# **A Cost-Effective, Cleaner Energy Portfolio for Duke Energy Indiana Customers**

**Public Version**

**Chelsea Hotaling, Energy Futures Group  
Anna Sommer, Energy Futures Group**

**May 2022**

**Figure 2. MISO Futures Solar Capacity Credit (%)<sup>18</sup>**

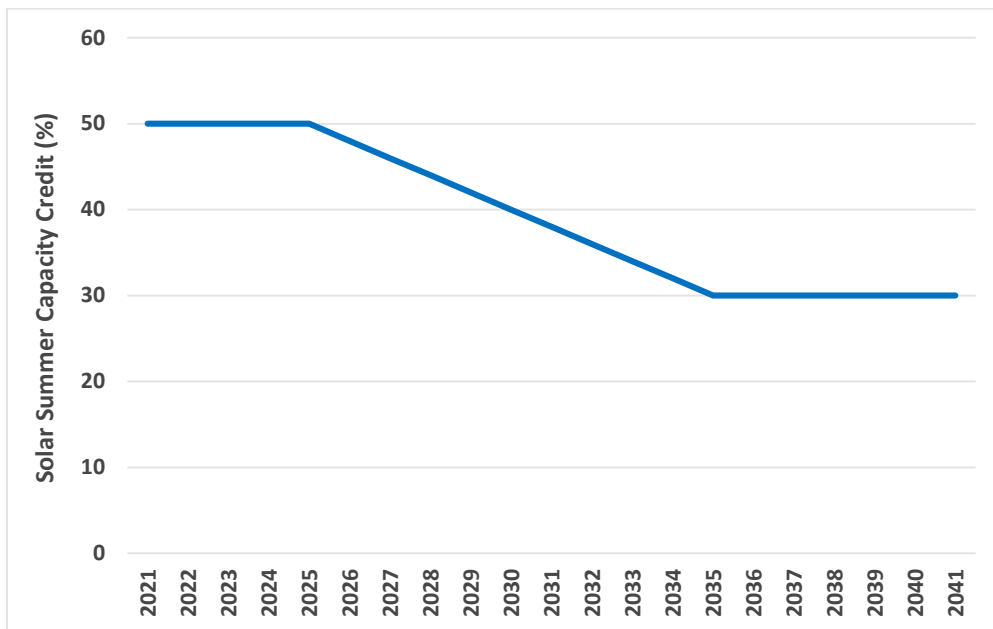
Though unrelated to the move to a seasonal construct, we also used the MISO Futures Modeling to develop a declining capacity credit assumption, shown in Figure 2, for the summer months to better reflect information from MISO.<sup>17</sup>

MISO has suggested that there will be accreditation benefits for wind resources in the winter months when wind typically produces more energy and therefore will have a higher accredited value. One of

**Figure 3. CAC’s Duke Revised Preferred Expansion Plan<sup>22</sup>**

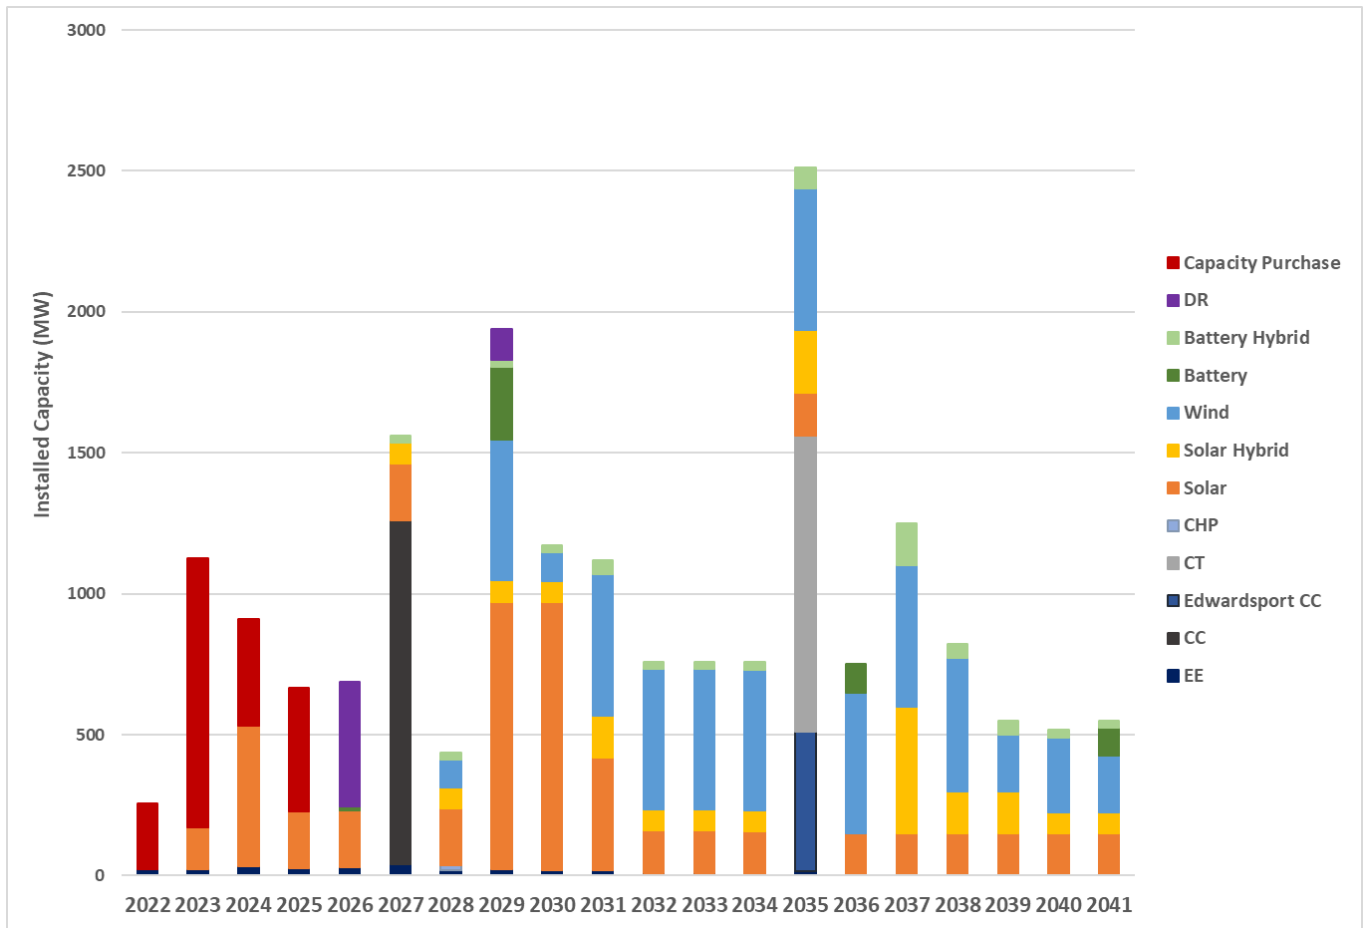
The EFG modeling runs included the changes made to Duke’s EnCompass database as discussed in Section 1.2 of this report. For the Duke Revised Preferred Plan, we fixed in the supply side resources that were in Duke’s Preferred Plan as filed with the IRP, but we did allow the model to optimally select additional resources given the modeling changes that we made. **Figure 3** shows the annual capacity expansion plan for the Duke Revised Preferred Plan. In certain years, the model did optimally select additional resources to add to the capacity expansion plan in addition to the resources that were included in Duke’s as-filed Preferred Plan. For instance, our Duke Revised Preferred Plan has some standalone battery storage added in 2029, 2036, and 2041, whereas Duke’s Preferred Plan presented in the IRP never added any standalone battery storage. This is likely a product both of our changes to Duke’s battery storage inputs, but also the change in the accredited value of its thermal units.

**Figure 4. The CAC Preferred Expansion Plan**

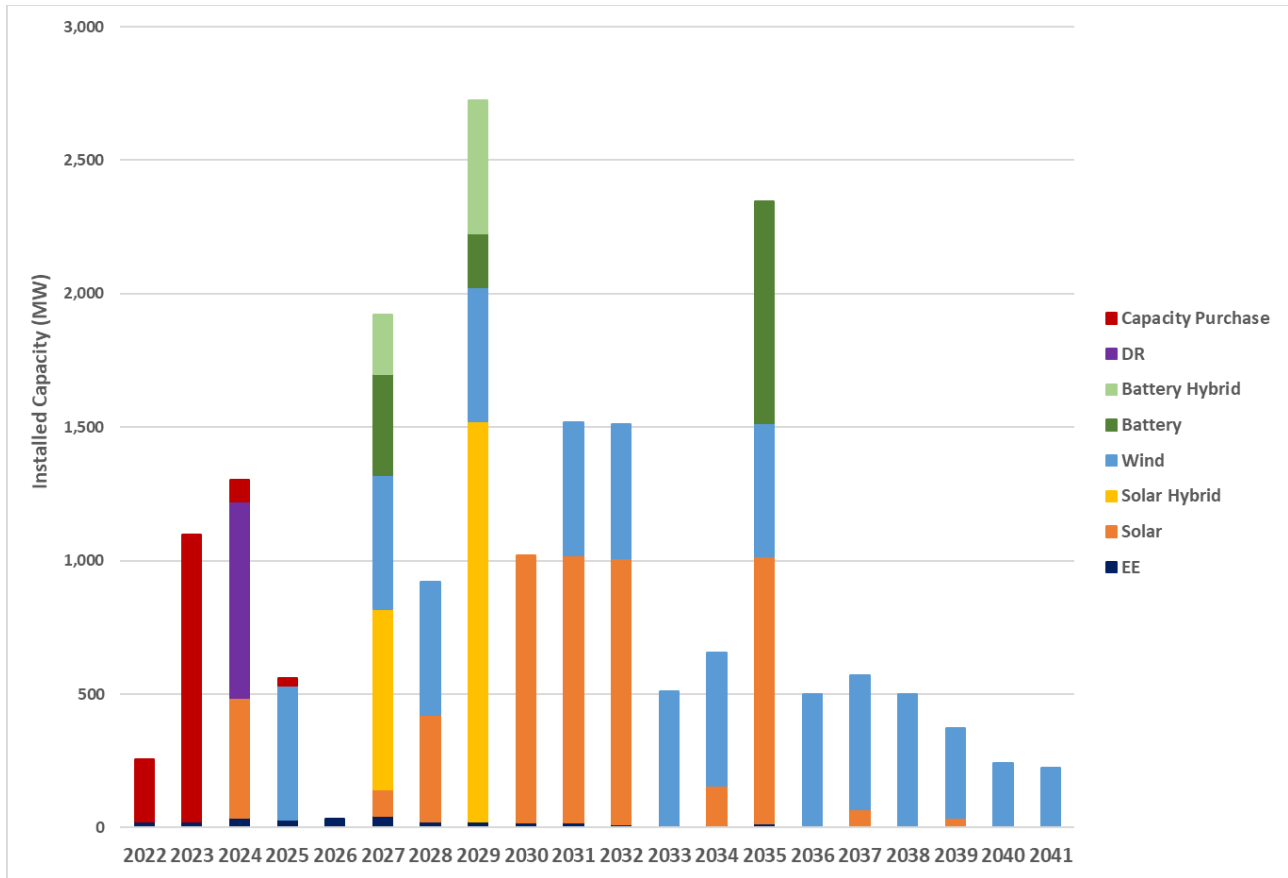
Figure 4 shows the annual capacity expansion plan for the CAC Preferred Plan. Two of the main differences between the Duke Revised Preferred Plan and the CAC Preferred Plan are the replacement of new thermal builds with renewables and storage, and an earlier conversion date of Edwardsport to natural gas. Instead of the CC in Duke’s Revised Preferred Plan, the model adds a combination of solar, solar hybrids, wind, and battery storage capacity in the CAC Preferred Plan. In addition, EnCompass also chose to convert Edwardsport at the earliest date available in the model, which is 2023. The CAC Preferred Plan also includes additional demand response resources in 2024 along with the larger Expanded Measures + Avoided Cost energy efficiency bundles.

Figure 6. CO<sub>2</sub> Emission Comparison (Tons)

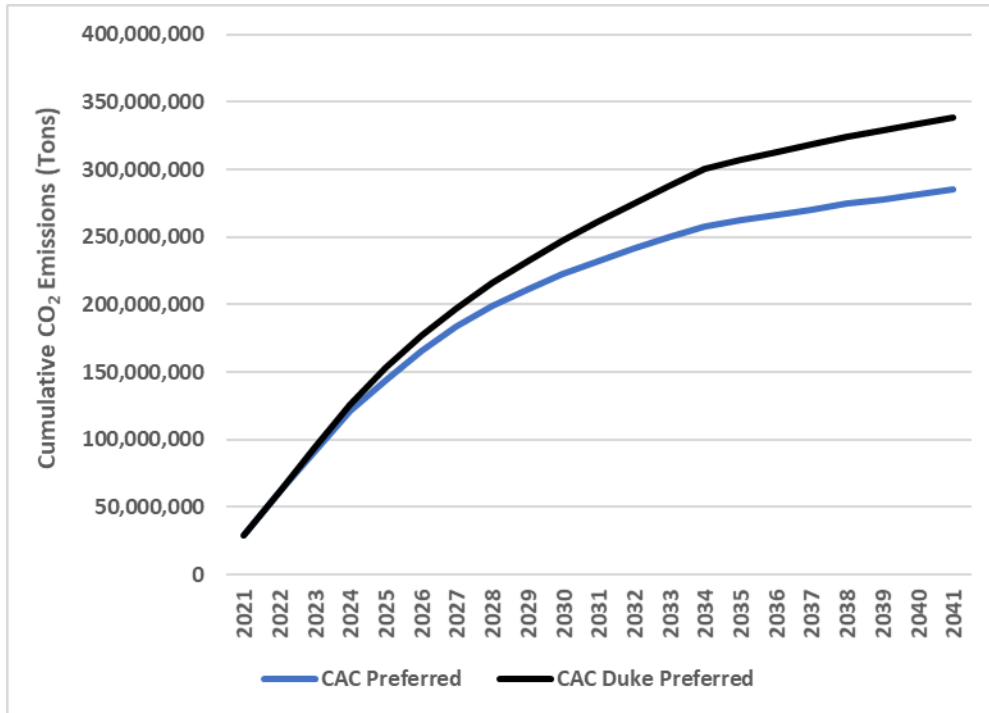
In addition to having a lower PVRR, the CAC Preferred Plan also has lower cumulative emissions between 2021 and 2041 compared to the Duke Revised Preferred Plan. Figure 6, below, shows the comparison of the cumulative CO<sub>2</sub> emissions between the CAC Preferred Plan and the Duke Revised Preferred Plan. The cumulative CO<sub>2</sub> emissions from the CAC Preferred Plan are about 16% lower than the cumulative CO<sub>2</sub> emissions from the Duke Revised Preferred Plan.
